Value Engineering Study Report

VE Study Number 201401
KY-15 Improvements
Perry County, Kentucky
Item No. 10-158.00
VE Study - April 21-25, 2014
Final Report

The subject of the VE Study was KY-15 Improvements project in Perry County, Item #10-158.00. The study was conducted April 21-25, 2014 with the presentation of findings held on April 25, 2014.

Figure 8 - VE Team recommended girder layout

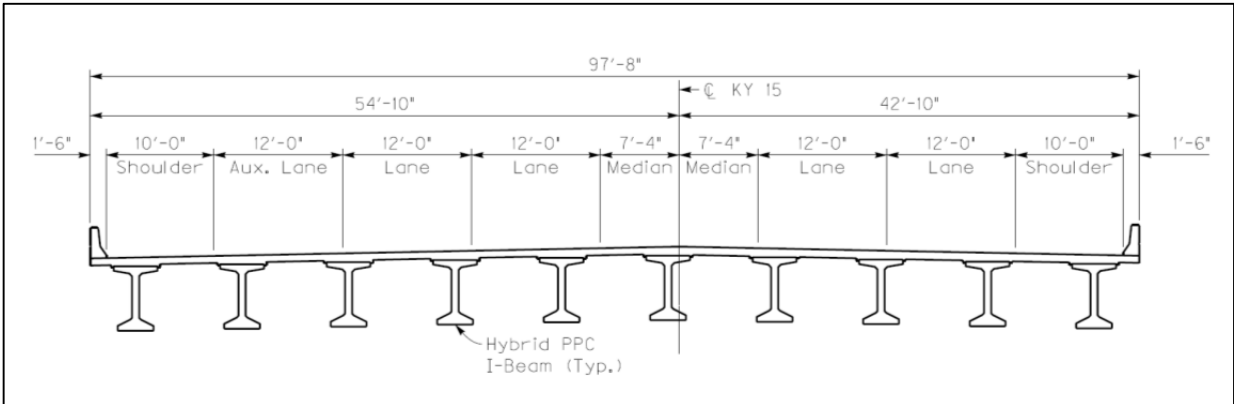
Recommendation VE-1 River Bridge		IDEA NO. 3	
Original Design			
<p>The current design conservatively assumed utilizing 8' deep steel girders in the superstructure. The existing structure has a center span length over the river of 178'. By holding this span length and adjusting for the increased skew the resulting span length could be as much as 188'. It's likely that an economical steel bridge would be a 4 span bridge with a maximum span close to 200'.</p>			
Recommended Change			
<p>Adjust the span lengths so that 150' pre-stressed concrete girders can be used.</p>			
Advantages		Disadvantages	
<ul style="list-style-type: none"> ▪ Allows a more economical superstructure ▪ Improved long-term maintenance ▪ More common construction 		<ul style="list-style-type: none"> ▪ Longer (but fewer) pieces to ship ▪ Heavier pieces to erect – larger cranes, crane pads, etc. ▪ Will require up to 2 additional piers.

Assumes that 150'+ girders can be transported to the project site.
 Assumes the additional pier(s) does not adversely affect the hydraulics.
 Assumes that the steel bridge utilized painted steel girders. The use of weathering steel would reduce long term maintenance costs.

69,602 SF x 35 lbs/SF = 2,436,070 lbs of Structural Steel = 1,218 Tons
 Repaint Cost = 1,218 Tons x \$250/Ton = \$300,000 to Repaint Bridge. Assume 2 repaint cycles over 75 year life of bridge.

Figure 10 – VE Team recommended KY 15 Typical Sections

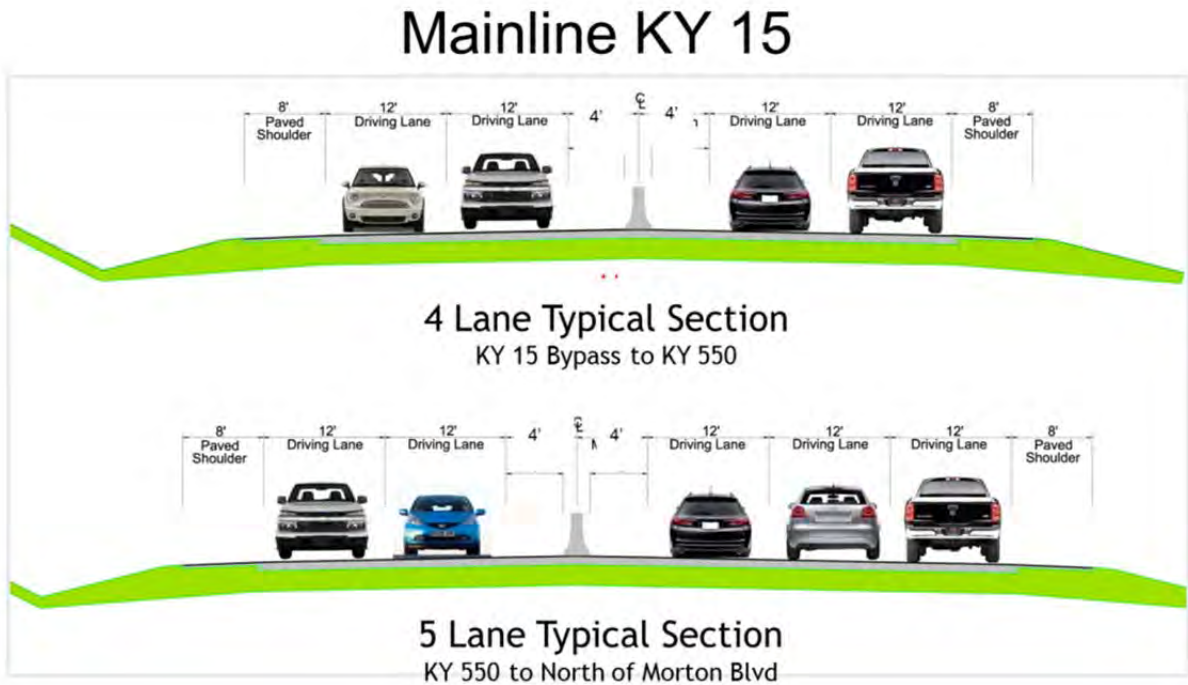
Recommendation VE-2		IDEA NO.	
Median Width		12	
Original Design			
Alternative 6 - Median with 6' inside shoulders and concrete barrier wall.			
Recommended Change			
Reduce the median width to 4' inside shoulders with a concrete barrier wall.			
Advantages		Disadvantages	
<ul style="list-style-type: none"> ▪ Less right of way to purchase ▪ Less earthwork costs ▪ Less asphalt pavement costs ▪ Less crushed stone base costs ▪ Less impervious pavement 		<ul style="list-style-type: none"> ▪ Reduces shy distance to barrier ▪ May reduce operations of mainline ▪ May impair sight distance for south bound KY 15 (south of Morton Blvd.) ▪ May increase number of drainage inlets in median. 	
Summary of Cost Analysis			
	Original Design	Recommendation	Estimated Savings
First Cost	\$10.72M	\$10.33M	\$0.39M x 56% markup = \$0.61M
FHWA Functional Benefit			
Safety	Operations	Environment	Construction
			✓

Design Memorandum 01-14 DRAFT addresses reducing the inside shoulders of divided highways from 6' wide to 4' wide

- Reduces foot print of typical section by 4'
- Reduces pavement costs for entire alignment
- Reduces earthwork costs for entire alignment

Double face guardrail was analyzed, but determined to be more expensive than concrete barrier wall based on recent bid documentation.

VE-2	✓	Median Width - Reduce the median width to 4 foot inside shoulders with a concrete barrier wall.	UC - 6/9/14		\$16,718,128	\$16,109,855	\$608,274		Construction	The Project team will consider using 4' inside shoulders as the project moves forward. The Project Team will also explore using 4' inside shoulders in the 2 lane sections along proposed KY 15, and using 8' inside shoulders in the 3 lane sections along proposed KY 15. In these areas (e.g. when there are 2 lanes SB & 3 lanes NB) there would be no change in the roadway footprint versus the baseline proposed design (both inside shoulders = 6'), so there would be no cost savings, but there would still be value added by having a 8' inside shoulder along the 3 lanes sections, due to having a shoulder with sufficient width that it could be used as an emergency lane by motorists.
VE-3	✓	Roadway Section - The VE Team recommends ending the acceleration ramp from KY 550 NB at the proposed right-in/right-out Willies Way southern intersection. KY 15 from the Willies Way southern intersection (Sta. 360+50) to north of Morton Boulevard (Sta. 383+00) will be two lanes northbound and southbound.	N		N/A	N/A	\$2,440,807		Environment Construction Other	The Project Team does not plan to implement this VE recommendation, due to operational considerations. The third uphill lane will act as a truck climbing lane. If this lane is ended prior to the crest of the hill trucks will be forced into the second lane at a point when the trucks are traveling at a very low speed, therefore reducing capacity and potentially causing a merge problem. Also, many truck drivers familiar with the area may not even utilize the third lane if it were to end at the proposed right-in/right-out Willies Way due to merge difficulties this arrangement could have. If this happened, there would be slow moving trucks in the middle (second) lane and potentially faster moving vehicles passing on the right in the shortened third lane, causing a potential safety hazard. Lastly, the public was in favor of having three lanes uphill by a vote of 17-0 at the public meeting.

Figure 11 - Location of 3rd Northbound Lane

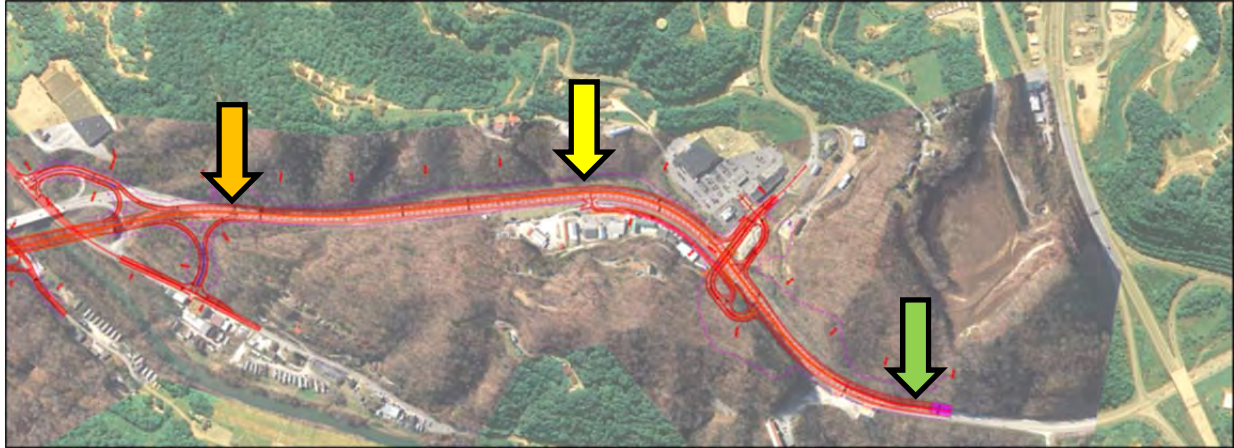
The original design of KY 15 has three northbound lanes running from the on-ramp at KY 550 (orange arrow on figure below) uphill and ending north of Morton Boulevard at approximate Sta. 383+00 (green arrow).

The VE Team recommends ending the northbound on-ramp from KY 550 at the proposed right-in/right-out Willies Way southern intersection (yellow arrow). Northbound KY 15 from the Willies Way southern intersection (Sta. 360+50) to north of Morton Boulevard (Sta. 383+00) will be two lanes.

Alternative 4, developed by the Project Team, is similar to this recommendation. The difference is that this recommendation increases the length of the acceleration lane by approximately 1,100 feet, dropping it north of southern Willies Way intersection to accommodate acceleration from Willies Way. This recommendation will reduce construction costs (less pavement and excavation), reduces environmental impacts, reduces long term maintenance and reduces the amount of impervious surface.

Figure 12 - VE Recommended intersection at Cherokee Hills Road

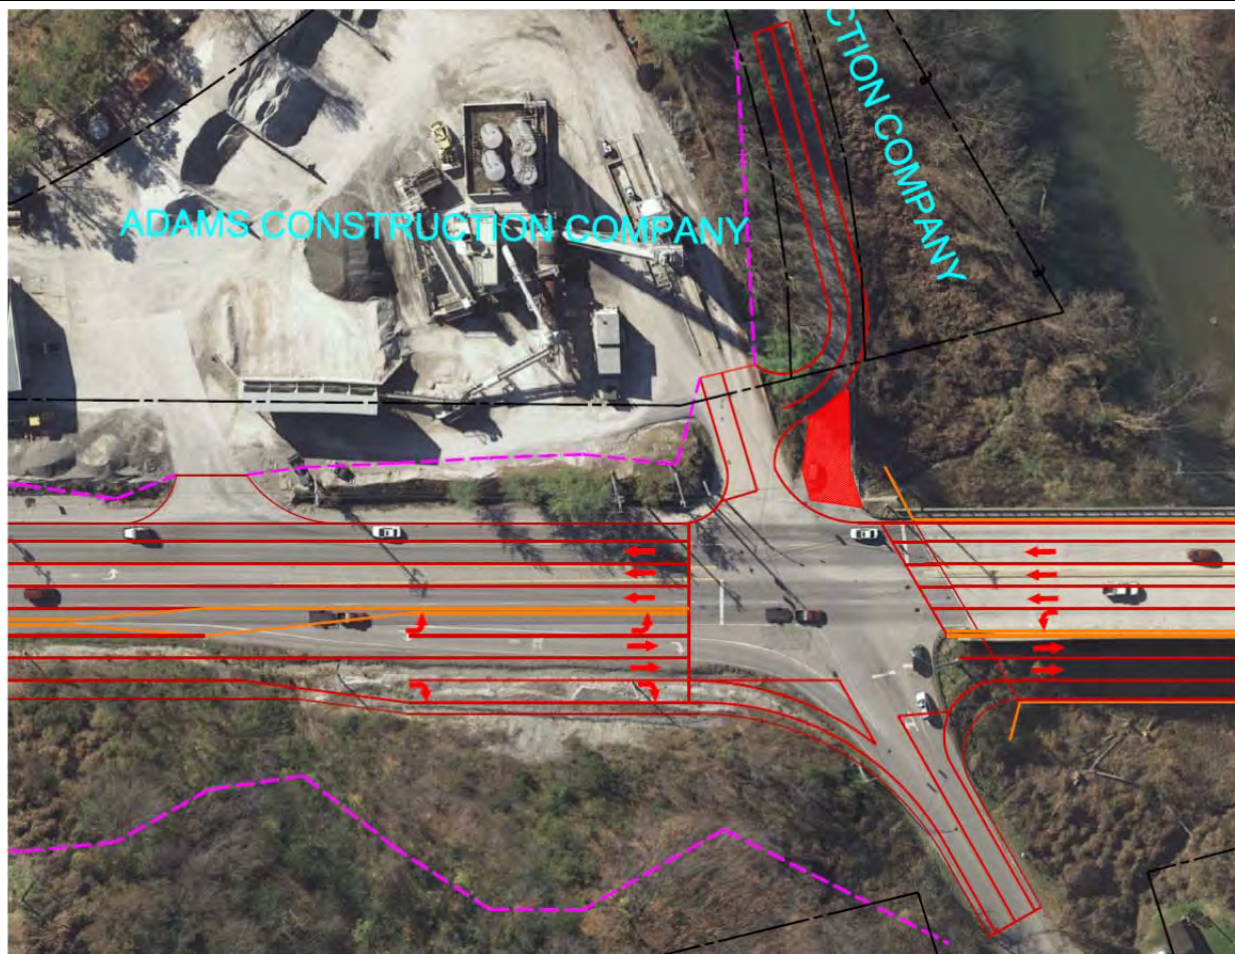
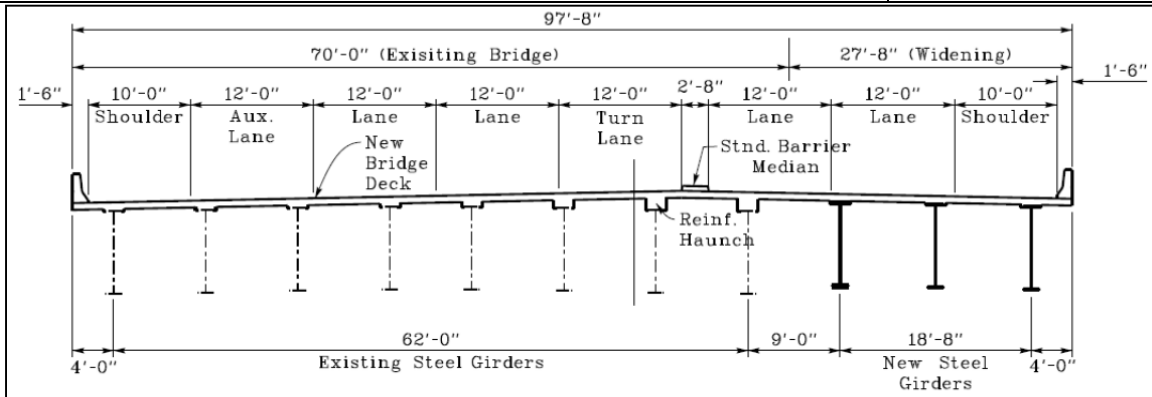
Recommendation VE-4 Perry Park Road			IDEA NO. 5, 6, 16, 19, 22	
Original Design				
Alternative 6 – The intersection of KY 15 with Perry Park Rd., Cherokee Hills Rd., and the entrance to the Asphalt Plant is relocated to the south and east. New frontage roads are provided on both sides of the new KY 15 alignment to provide right-in/right-out access for Cherokee Hills Road, Asphalt Plant, Shell station, Pawn Shop, and Perry Park Rd. from both directions. A portion of the existing Perry Park Road is shifted to the north to pass under the proposed bridge.				
Recommended Change				
Maintain existing KY 15 alignment with widening to the east. Keep the existing signalized intersection for Perry Park Road, Cherokee Hills Road and the Asphalt Plant north entrance. Realign the intersection’s eastbound approach to provide direct access to the Asphalt Plant and modify Cherokee Hills Road so that it “Tees” into the new Asphalt Plant access. Widen and rehabilitate the existing bridge to provide a southbound auxiliary lane, 2 southbound through lanes, and a left turn lane from KY 15 onto Perry Park Road. The speed limit along KY 15 from the river bridge to KY 15 bypass may need to be reduced to 45 MPH.

<p style="text-align: center;">Recommendation VE-4 Perry Park Road</p>	<p style="text-align: center;">IDEA NO. 5, 6, 16, 19, 22</p>
<p>Justification</p>	
<p>The VE Recommendation is to maintain the existing KY 15 alignment with widening to the east and keeping the existing signalized intersection for Perry Park Road, Cherokee Hills Road and the Asphalt Plant north entrance.</p> <p>The recommendation would realign the intersection’s eastbound approach to provide direct access to the Asphalt Plant and modify Cherokee Hills Road so that it “Tees” into the new Asphalt Plant access.</p> <p>The existing river bridge would be widened (27’ 8”) to accommodate the additional lanes and rehabilitated to provide additional capacity. The speed limit along KY 15 from the river bridge to KY 15 bypass may need to be reduced to 45 MPH.</p> <ul style="list-style-type: none"> • This recommendation does add another signal on KY 15, which will reduce the performance along the mainline when compared to the original design of Alternative 6. • This recommendation causes the Shell Station and Pawn Shop to have right-in/right-out access, whereas they were accessing KY 15 via a frontage road in Alternative 6 • Because this recommendation follows the existing alignment, maintenance of traffic (MOT) will be more complex during construction • Enforcement may be needed if it is decided to reduce the speed limit along KY 15 through this section. • Maintaining an alignment that more closely follows the existing KY 15 alignment reduces the amount of excavation on the right side of Section 1 (POB to the River bridge). This will significantly reduce the amount of excavation that has to be hauled across the river to a waste site. • Maintaining the existing alignment allows for the existing bridge to be re-used for the SB lanes. This reduces the amount of new structure to build since you would basically be widening the existing bridge to accommodate northbound traffic. The existing bridge would need to be rehabilitated and widened, which would require more life cycle (maintenance) cost versus a totally new bridge, but the cost of widening and rehabilitating a 400’ bridge versus building a completely new 700’ bridge is significantly less. • This recommendation requires less right-of-way. This means that the Exxon Station and the residents on Fugate Mountain will likely not have to be purchased and/or relocated. (Note: If these parcels are not purchased, then they would have right-in/right-out access to KY 15.) • All of these advantages significantly reduces the initial project costs • Despite the reduction in performance along the mainline, the significant savings in cost create a positive added value for the project. <p><u>Notes & Discussion about re-use of existing bridge:</u></p> <p>Overall, the existing bridge, built in 1965, is in great condition. It has a sufficiency rating of 92.6, which is better than most bridges in the State, including much newer bridges.</p> <p>Only 3 girder lines would need to be added to the existing cross section. The current inventory rating is 42.4 tons, which is more than sufficient. However, additional capacity can be achieved by installing shear studs on the existing girders during deck replacement. In order to not have to remove cross frames, accommodating the new bridge cross slope would require a larger than normal haunch between the top of some girders and the bottom of the proposed deck. This haunch area could be reinforced to provide proper composite action.</p>

In theory, the existing steel girders could have a finite fatigue life. The longitudinal web stiffeners appear to be located on the compression side of the web. Near the field splices there could be a stress reversal causing tension, but the stresses would be relatively low. In addition, the lateral bracing in the exterior bays are attached to the bottom flange by gusset plates that are fillet welded. A remaining fatigue life analysis could be performed and dye penetrate testing of areas of concern, if any. It is likely the lateral bracing could be removed and the flanges ground smooth if there is any concern.

VE-4	✓	Perry Park Road - Maintain existing KY 15 alignment with widening to the east. Keep the existing signalized intersection for Perry Park Road, Cherokee Hills Road and the Asphalt Plant north entrance. Realign the intersection's eastbound approach to provide direct access to the Asphalt Plant and modify Cherokee Hills Road so that it "Tees" into the new Asphalt Plant access. Widen and rehabilitate the existing bridge to provide a southbound auxiliary lane, 2 southbound through lanes, and a left turn lane from KY 15 onto Perry Park Road.	N		\$31,976,136	\$13,624,033	\$18,352,103	\$43,000	Environment Construction	The Project Team does not plan to implement this VE recommendation due to the much lower level of performance along the mainline and the reduction in performance to local operations. Also, the baseline design provides better access control and hence safety by providing a frontage road for the Asphalt Plant, Cherokee Hills Rd, Shell Station, and Pawn Shop. Finally, the Project Team had some concerns that the projected \$18 million in savings for this VE recommendation may not be accurate.

Figure 14 – VE Recommendation for Morton Blvd

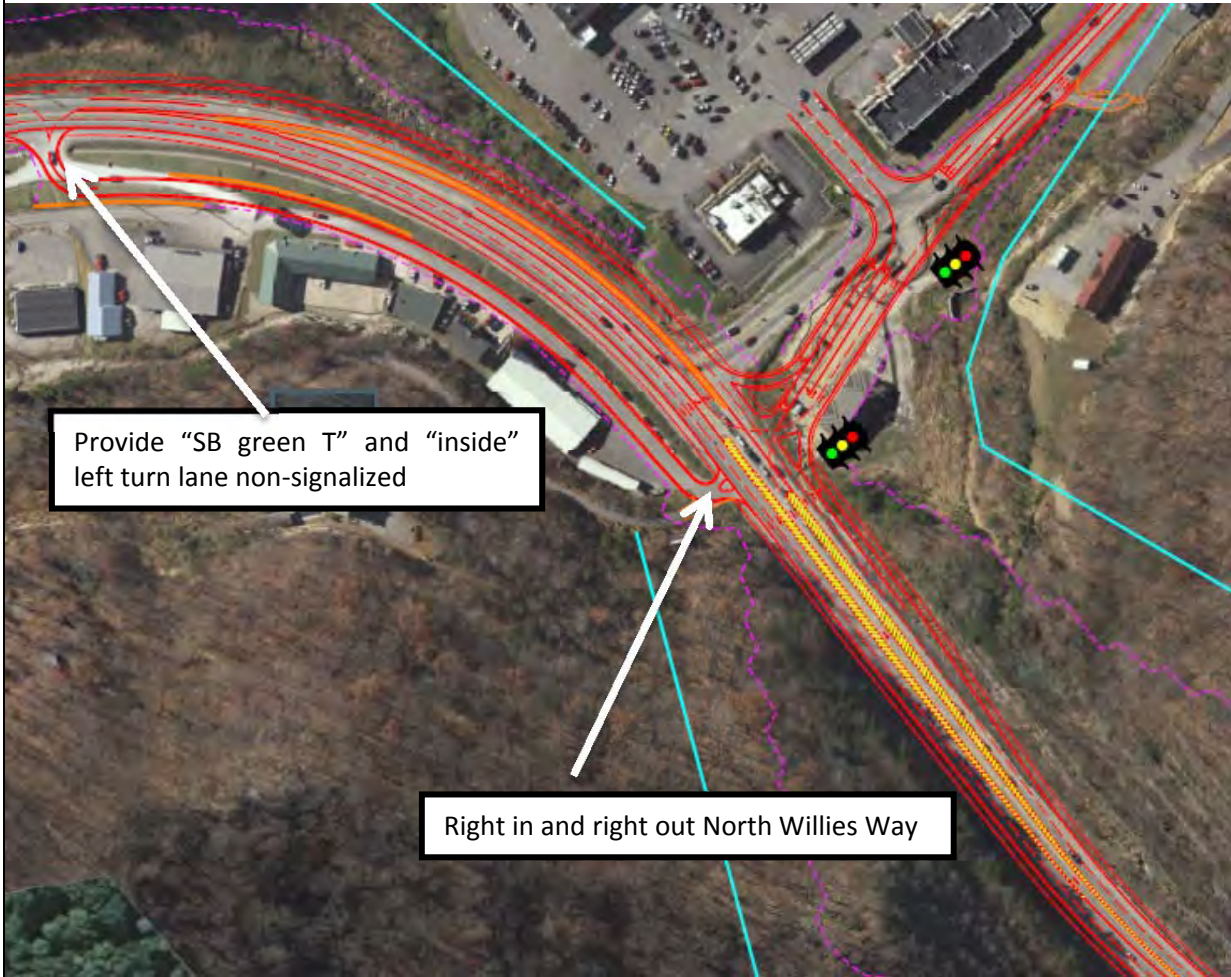
Recommendation VE-5 Morton Blvd.		IDEA NO. 9		
Original Design				
<p>Alternative 6 – Full interchange on KY 15 with Morton Blvd. and the north end of Willies Way. Willies Way will also be improved and a right-in/right-out entrance provided at the south end of Willies Way. The alignment of Morton Blvd. is shifted slightly to the north to minimize right-of-way taking on the east side of KY 15 and to provide a slip ramp for eastbound right turns from Morton Blvd. to southbound KY 15.</p>				
Recommended Change				
<p>Provide signalized intersection at Morton Blvd. (similar to proposed design shown in Alternate 4) with:</p> <ul style="list-style-type: none"> ▪ Dual northbound left turn lanes from KY 15 to Morton Blvd. ▪ Single eastbound left turn lane from Morton Blvd. to KY 15, utilizing “green” or “inside” left turn lane ▪ Right-in/right-out movement for westbound Willies Way approach (north end). <p>Provide unsignalized intersection at Willies Way (south end), also utilizing “green” or “inside” left turn lane for turning movements onto KY 15.</p>

Advantages		Disadvantages		
<ul style="list-style-type: none"> ▪ Significantly less cost ▪ Northbound mainline does not stop at intersection ▪ Less confusion for traveling public ▪ Less right-of-way is required ▪ Reduces earthwork ▪ Reduces maintenance without bridge 		<ul style="list-style-type: none"> ▪ Left hand merge onto mainline ▪ Added signal to southbound mainline ▪ Additional maintenance of traffic (MOT) will be required ▪ Snow and ice removal may be more difficult 		
Summary of Cost Analysis				
	Original Design	Recommendation	Estimated Savings	
First Costs - Construction	\$5.35M	\$3.50M	\$1.85M x 56% markup = \$2.89M	
First Costs – Right-of-Way	\$1.00M	\$0.50M	\$0.50M	
O&M Costs		\$20/month for 20 years		
FHWA Functional Benefit				
Safety	Operations	Environment	Construction	Other
			✓

VE-5	✓	Morton Blvd - Provide signalized intersection at Morton Blvd. (similar to proposed design shown in Alternate 4) with: - dual northbound left turn lanes from KY 15 to Morton Blvd. - single eastbound left turn lane from Morton Blvd. to KY 15, utilizing "green" or "inside" left turn lane - right-in, right-out movement for westbound Willies Way approach (north end). Provide unsignalized intersection at Willies Way (south end), also utilizing "green" or "inside" left turn lane for turning movements onto KY 15.	N		\$9,346,000	\$5,960,000	\$3,386,000	-\$4,800	Construction	The Project Team does not plan to implement this VE recommendation. A very similar scenario had been previously looked at by the Project Team and was rejected. Extensive queues are anticipated along KY 15 and Morton Boulevard because of the large volumes of turning traffic. This coupled with a higher number of conflict points than the baseline proposed design may result in safety concerns at an intersection that already has a CRF of 1.58. Finally, the majority of the public supported a grade separated interchange in lieu of a "green T" intersection.
